Justification for Class III Permit Modification March 2005 SWMU 159 Operable Unit 1303 Building 935 Drain Systems at Technical Area II

Sandia National Laboratories/NM

Comment Response October 1996

RSI Response June 2004

Figure 2. Map Showing ER Site 159 Building 935 Septic System

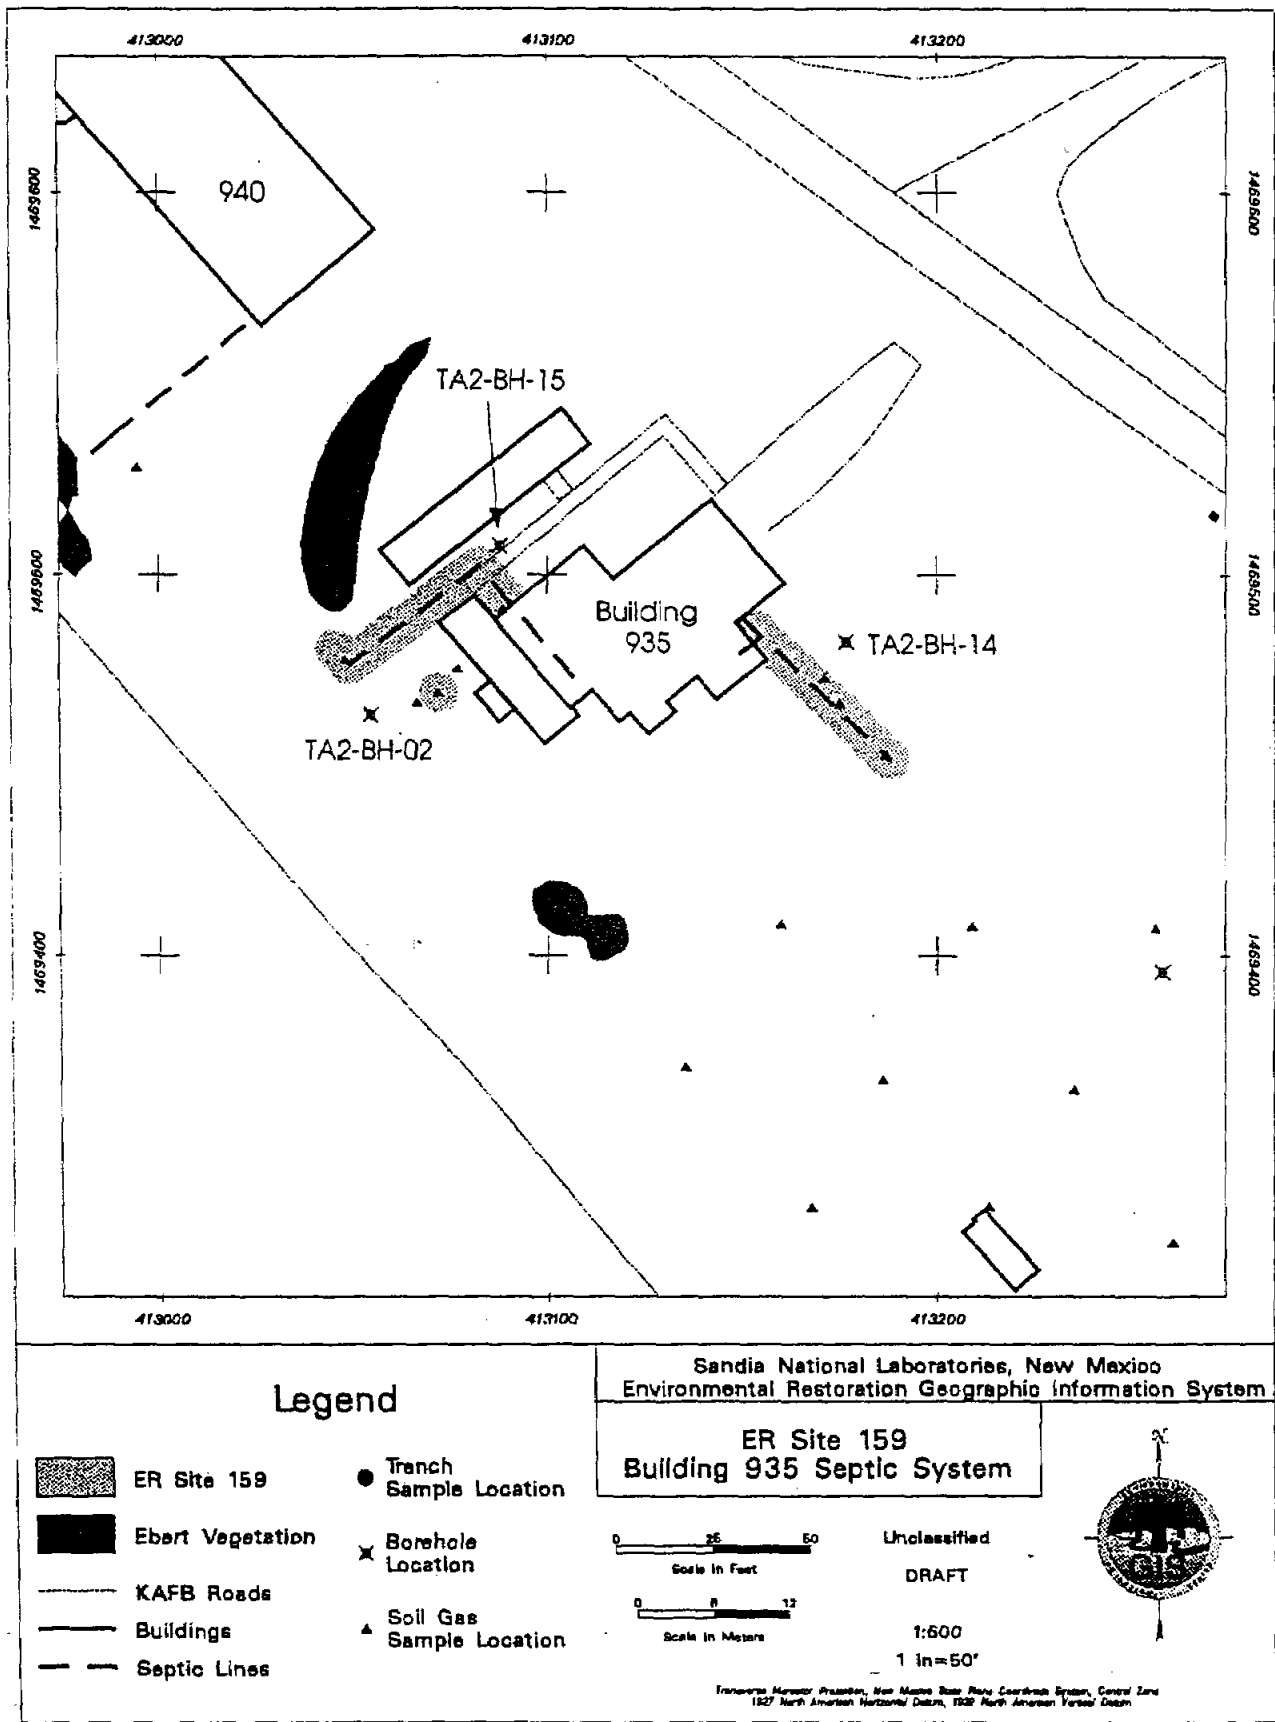
- e. **What are the potential constituents of concern?**
- f. **Please provide a more detailed map of Figure 2. In addition, please provide a more detailed schematic or map of the sanitary system which clearly identifies all components of the system. Lastly, please provide further information of the retention tank, including a description of what the tank is constructed of.**
